Office Action Summary

10/058,029

DETAILED ACTION

The specification and the Drawings as originally filed provides for the user requesting the speed. See for example a portion of Applicant's originally filed Figure Drawing 6.

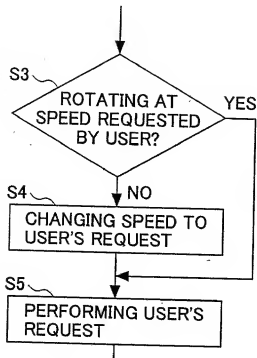
The amendments made to Figures drawings 6- 11, in the steps “s3” and “s4” of “Suitable for User’s request” and “Changing speed of spindle motor”, respectively, introduces New Matter.

The Examiner cannot concur with the Applicant because the amended drawings introduces subject matter of "determining if the first rotation mode is not suitable for the storing and reproducing of the user's request", which is not supported by the original disclosure.

The examiner cannot concur and disagrees with the Applicant because the expressly recitation from the specification original originally filed is as follows: "*If the disc is not rotating at a speed corresponding to the speed of storage and reproduction designated by the user (N*

branch of S3)". Hence, contrary to the Applicant assertions the user does designate the specific rotation speed during the storage and reproduction processes. The user requests the recording and/or reproduction and designate the speed as clearly explained.

However, contrary to the Applicant's assertion the Drawings as originally filed, and the specification, as originally filed, provides for whether the disc is rotating at a speed designated by the user, as outlined above.

As shown in the Figure step S3 expressly, clear and concise "rotating at speed requested by user" and further in step S4 "changing speed to user's request".

Applicant is required to cancel the new matter in the reply to this Office Action.
